Automatic Switch Co.

Subject: U.S. NRC Information Notice 89-66

"Field Notification Concerning the
Qualified Life of ASCO Catalog NP-1 Valves"

"Revised Field Notification
of the Discontinuation
of NP8323 Valve Line "

Revised Field Notification of the DISCONTINUATION OF NP8323 VALVE LINE

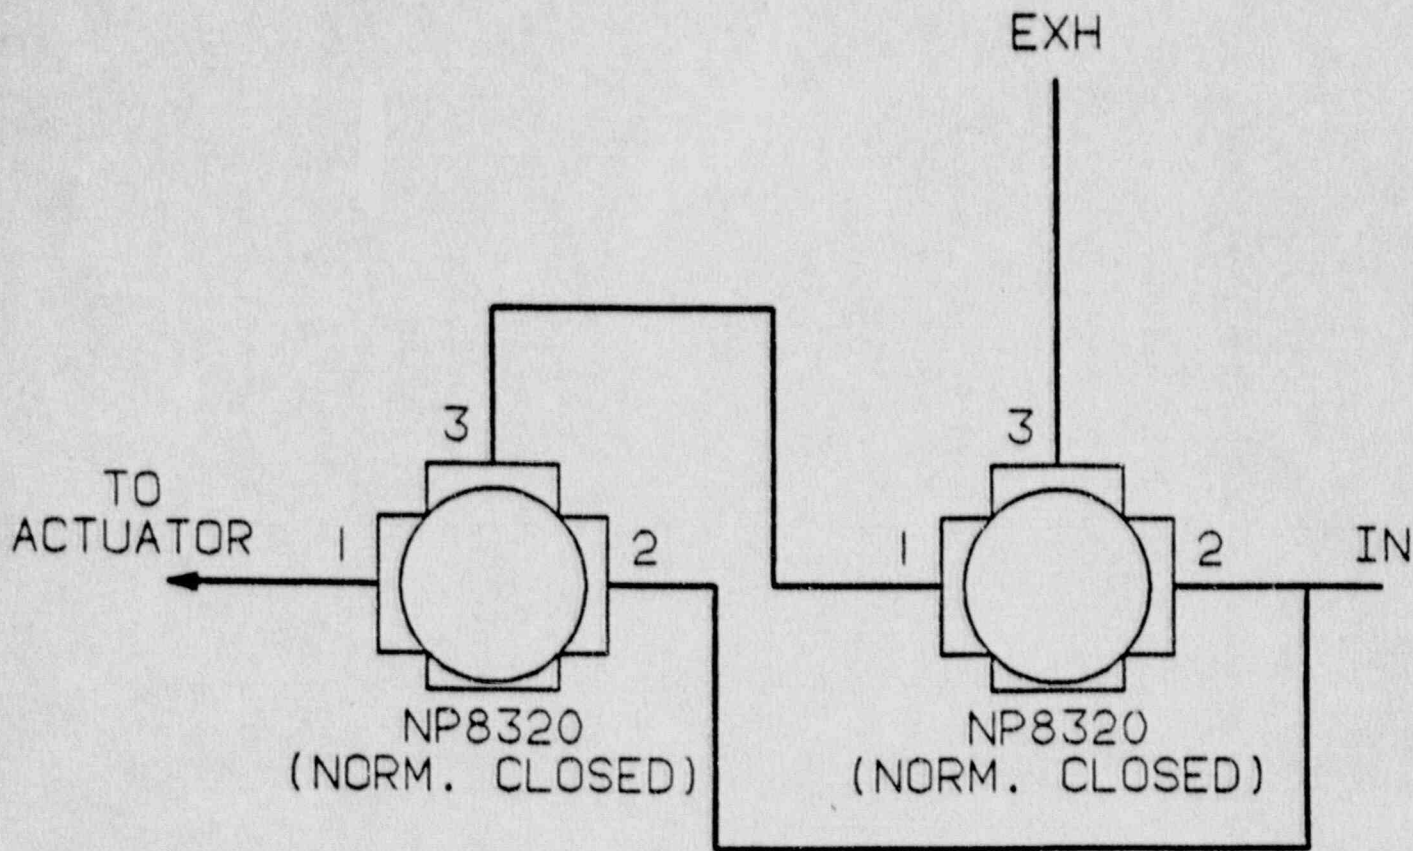
series valves (normally closed construction) can be piped in a configuration which will duplicate the function of the presently used NP8323 pilots. Please refer to drawing FP238900 attached. Like the NP8323 series, the NP8320 series valves are fully qualified for safety-related applications with the following advantages:
